## CITY OF FLORENCE PLANNING COMMISSION

## **RESOLUTION PC 14 28 CUP 11**

A REQUEST FOR A CONDITIONAL USE PERMIT AND DESIGN REVIEW, A request for approval of a Conditional Use Permit and Design Review to construct a 1,440 sq. ft. State Police Storage Building to be located at 4480-E Highway 101 North, Florence, OR, Assessor's Map 18-12-14-32 TL 00109, in the Highway District.

## STAFF REPORT & FINDINGS FLORENCE COMMUNITY DEVELOPMENT DEPARTMENT Planning Commission Exhibit "A"

# **EXHIBIT B**

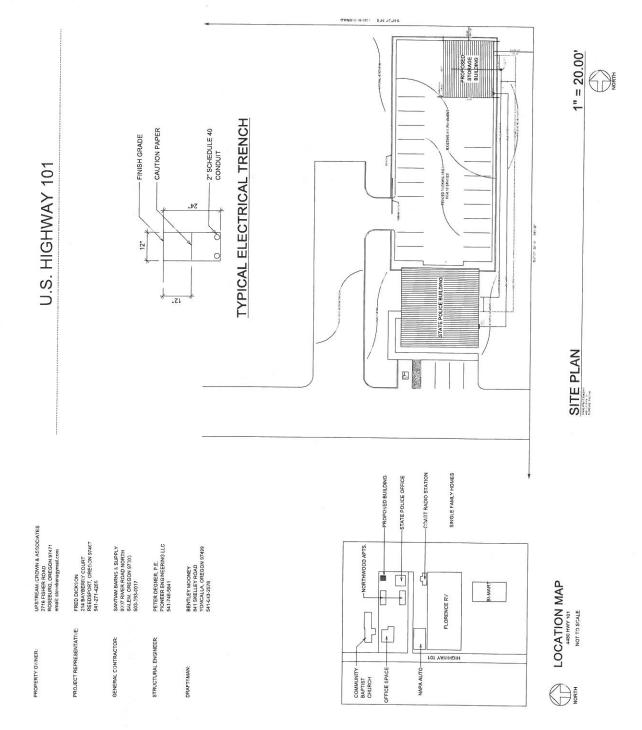
The proposed pole building is greater than the minimum 70 feet setback from the center of the highway right-of-way and therefore meets the highway setback criterion. The property does not abut any streets. The site plan illustrates that the proposed building will be situated approximately 10 from the northern property line and 27.5 feet from the eastern property line. However, the site plan also illustrates that the existing paving and fence line is approximately 10 feet from the northern property line. Aerials indicate that the pavement actually goes to the property line. Prior to building permit issuance the northern eastern property line corner shall be surveyed and staked. The building when constructed shall meet the minimum 5 foot north setback criteria. The eastern yard shall be a minimum of 15 feet as required to meet buffering criteria from the residential uses to the east. (Condition 5) The southern and western property lines are not affected. The proposal as illustrated on the site plan meets the setback criteria.

The lot boundaries provided by the applicant on the site plan are 282.5 ft. x 396 ft. (111,870 sq. ft.). The Regional Land Inventory Database indicates the property is actually 39,204 sq. ft. The site plan and aerial drafted by staff illustrate the vegetated areas. The maximum allowed impervious coverage is 33,323 sq. ft. (85%). The proposed building is to be located in area previously impervious so there is no change to the coverage. However, as proposed the site will include around 25,733 sq. ft. (65%) of impervious coverage and 13,471 sq. ft. (35%) of pervious coverage thereby meeting the 85% maximum lot coverage criteria.

The proposed pole building would be situated along 40 ft. of length of the eastern side yard abutting the single family residential district and uses. The site plan illustrates that there is 27 ft. of native vegetated setback from the proposed building to the property line and an existing fence 3 ft. or so from the proposed building. The proposed setback and existing vegetation along with adding slats to the existing chain link fencing would meet the code criterion. The applicant shall slat the chain link fence along the eastern property line for 40 ft. south of the proposed building. (Condition 6)

The site plan does not illustrate the location of any trash enclosures. All trash and recycling containers shall be stored indoors of be screened from the public by a solid fence, wall or landscaping. (Condition 9) Staff has reviewed the public health, safety and general welfare in other parts of this report and has either made positive findings or conditions. No other public health, safety, or general welfare concerns are found.

- 5. Prior to building permit issuance the northern eastern property line corner shall be surveyed and staked. The building when constructed shall meet the minimum 5 foot north yard setback criteria. The eastern yard shall be a minimum of 15 feet as required to meet buffering criteria from the residential uses to the east.

- **6.** The applicant shall slat the chain link fence along the eastern property line for 40 ft. south of the proposed building.
- 7. All proposed lighting shall meet current dark sky lighting code standards all existing lighting fixtures shall also be brought up to current code standards, if they do not already meet the requirements of FCC 10-37. All lighting fixtures are required to be full cutoff.

- **9.** All trash and recycling containers shall be stored indoors or screened from the public by a solid fence, wall or landscaping.

**EXHIBIT D**

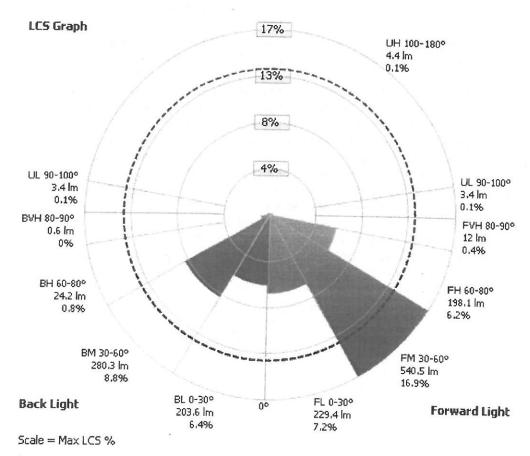
The applicant submitted a lighting plan with this application. The proposed light is a cut-off fixture rather than a full-cutoff fixture. The proposed lighting does not meet the full-cut-off criteria. The applicant shall provide revised lighting plans illustrating the type, brightness, height, and number of lamps and luminaires at the time of building permit application. (Condition 8)

- 8. The applicant shall provide revised lighting plans illustrating the type, brightness, height, and number of lamps and luminaires at the time of building permit application.
